APPLICATION FOR  
URBAN DESIGN COMMISSION  
REVIEW AND APPROVAL

PROJECT ADDRESS: 2222 S. PARK ST.

Re: Minor Alteration to a previously approved plan  
2222 S. Park St.

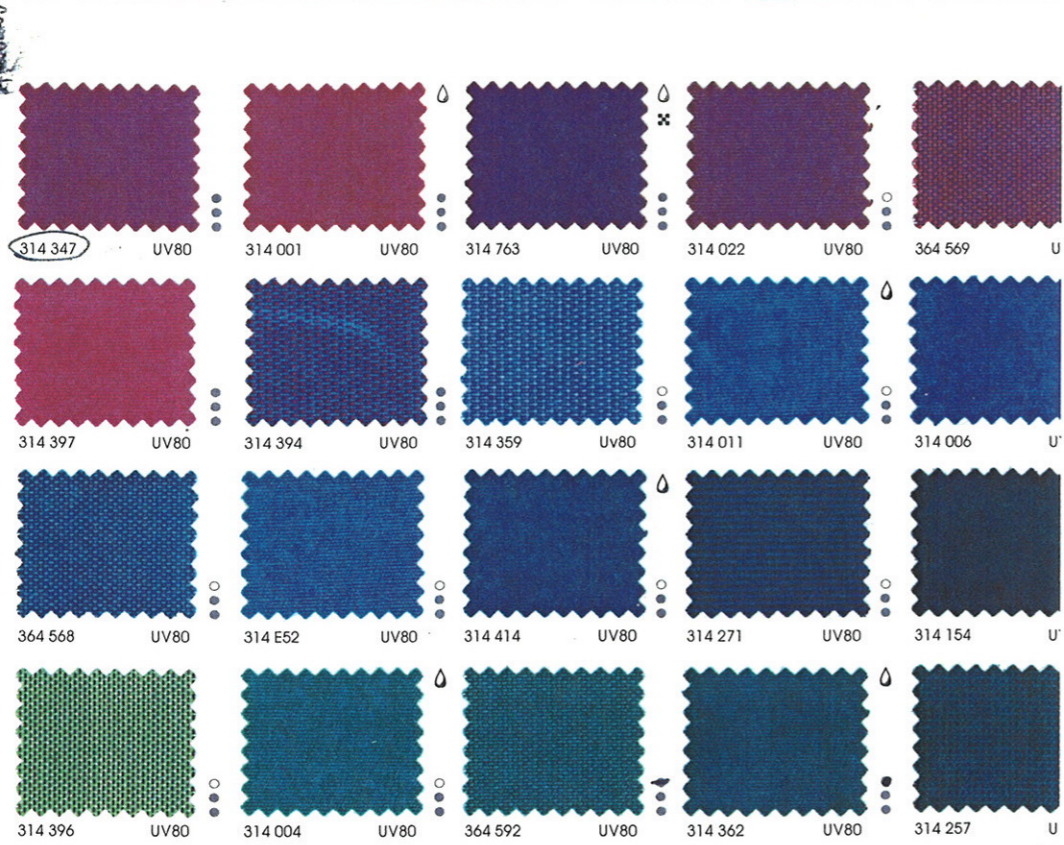
The previously approved plan had anticipated a color scheme shown in the approved renderings.

The actual materials used (supplier awarded the contract) had limited colors for the smooth metal panels used in the horizontal band. Although a "green" was available it is a primary green color vs. the soft anticipated. Poor timing on the suppliers submittals forced the project manager to order before we could have brought this back to UDC.

Project as previously approved.

Project as built.

We regret not submitting the color change prior to fabrication. The entire organization is now aware how critical this is. The entire team is very pleased with the revised final solution.
